# Union Road E4 Consultation

Exeter Cycling Campaign Response June 2021

# Shared Use

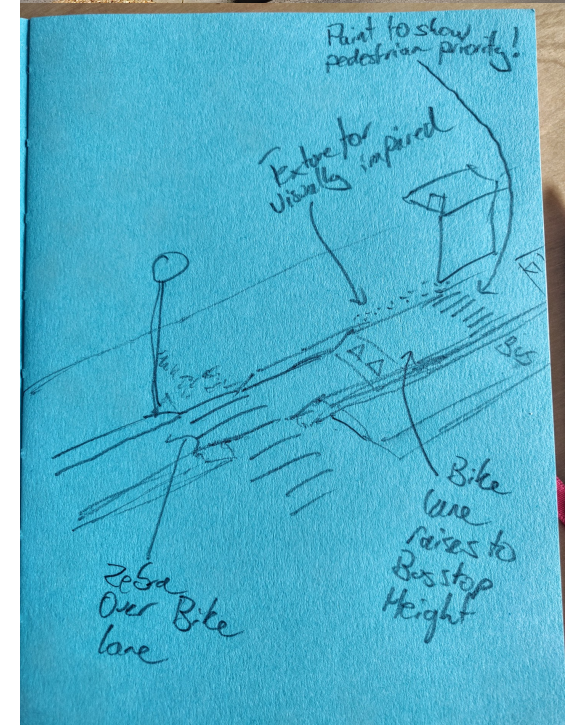
We believe the shared use section opposite Saunders convenience store could (and should) be avoided. A pattern used in other major cities is to keep the bus stop on the pavement and alight over the cycle lane, which is raised to the correct height to facilitate this. This ensures pedestrians and cyclists both know where they should be and only impede one another when a bus is present (with pedestrians always having clear priority). Photos and rough plans illustrating this are included.

# Pennsylvania Road Junction

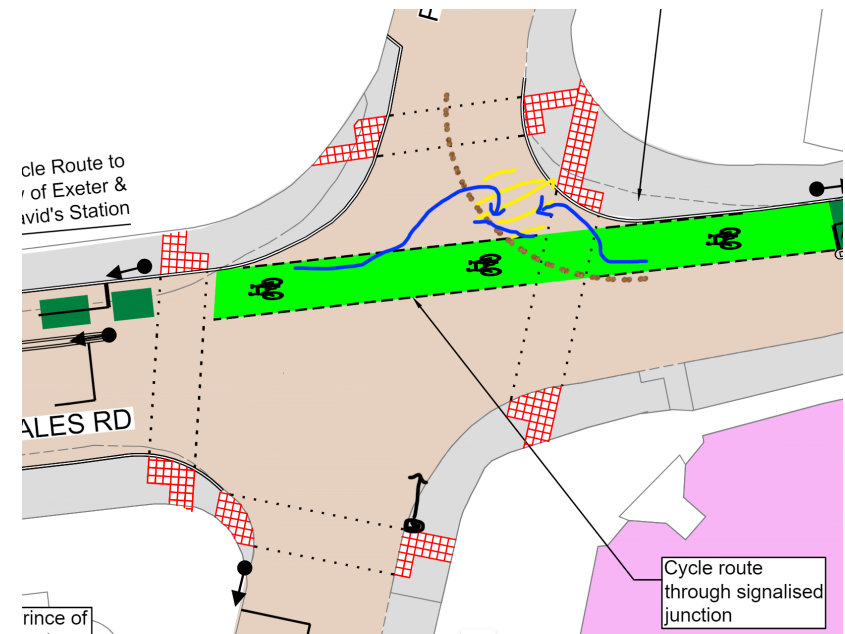
The inclusion of dedicated cycling provision is applauded but several routes through the junction do not feel like they have been considered (although phasing details are not presented in the proposals):

- Pedestrians crossing the Northern leg currently have no push button or lights. This is exacerbated on the north west corner where visibility is very poor up Pennsylvania road. This should be given a full signalled crossing as part of the redevelopment. Likewise crossing the Eastern leg. Given the north western pavement is the one bordering and accessing the university with large numbers of students on foot this seems something of an oversight! A marked diagonal crossing may also be beneficial.

- Cyclists turning from the E4 southbound. Assuming cyclists will be given a green light at the same time as the Union Road / Prince of Wales Road traffic then they will have to battle this to turn down to the city centre. This is particularly prevalent for those travelling west from the university as two of the preceding cut throughs are not available to cyclists (Lower St German is one way away from the city centre, Hooper Lane has restrictions) and the access via West Avenue can be very congested. Possible strategies for this include giving those turning a dedicated waiting space to wait for the southbound phase with suitable signage and paint to indicate this (safe zone in yellow hash, access paths in blue, extra light marked to let cyclists see phase), although this style of plans can be hard to make clear to cyclists and enforce. Another pattern is to create a dedicated turning phase for the cyclists but again this requires waiting space away from those trying to continue straight.

- Due to the one lane design of the beginning of Union Road cyclists will face being side swiped by traffic turning North from both Prince of Wales Road and Union Road - both will have cyclists close and in blind spots travelling the same direction for periods of time. Additional signage should be considered warning drivers, as well as reducing the speed limit.
- There is a risk of displacing traffic onto Maryfield Avenue and Sylvan Road. Particularly the latter may be a good candidate for a low traffic neighbourhood but traffic on these roads should be monitored pre and post changes to confirm impact.
